Global Service Action  
Number: D001

Subject: <b>Automatic Pressure Maintenance Unit (APMU) Hose Clearance to Heatshield</b>	Publication No.: D001
	Model: Defender (LE)
	Model Year: 2025 - 2026
	Date of Issue: 09 April 2025
	Expiry Date: 30 April 2027

**DESCRIPTION OF ISSUE**

E386588

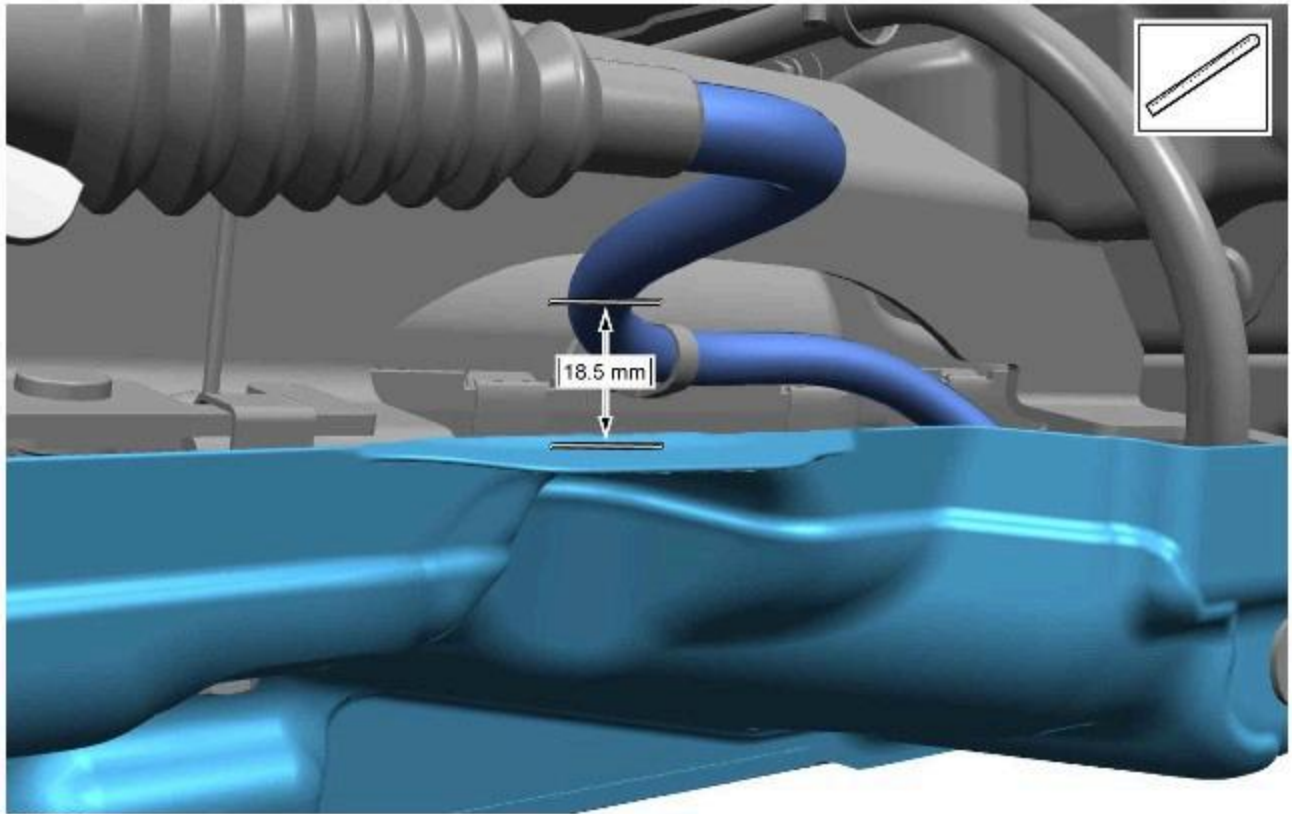
**CAUTION:**The clearance must be a **minimum** of 18.5 mm.

Using a suitable method, measure the clearance of the heatshield to the [APMU](#) hose.

- If the heatshield to [APMU](#) hose clearance is **18.5 mm or greater**, continue to step 4.
- If the heatshield to [APMU](#) hose clearance is **less than 18.5 mm**, continue to step 3.

E386587

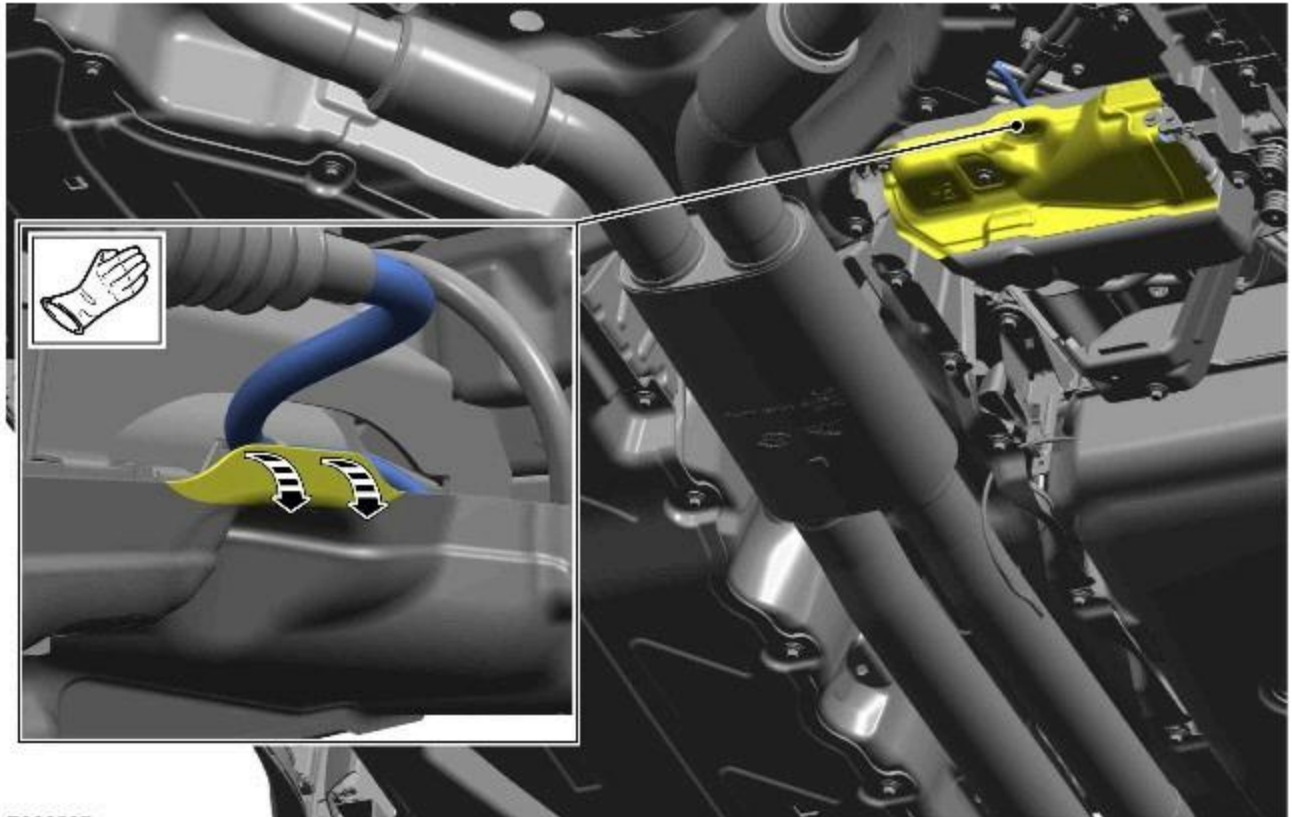
Protective hand wear must be used when repositioning the heatshield.

Using a suitable method, reposition the heatshield 90 degrees, in the area highlighted in the illustration, repeat step 2.
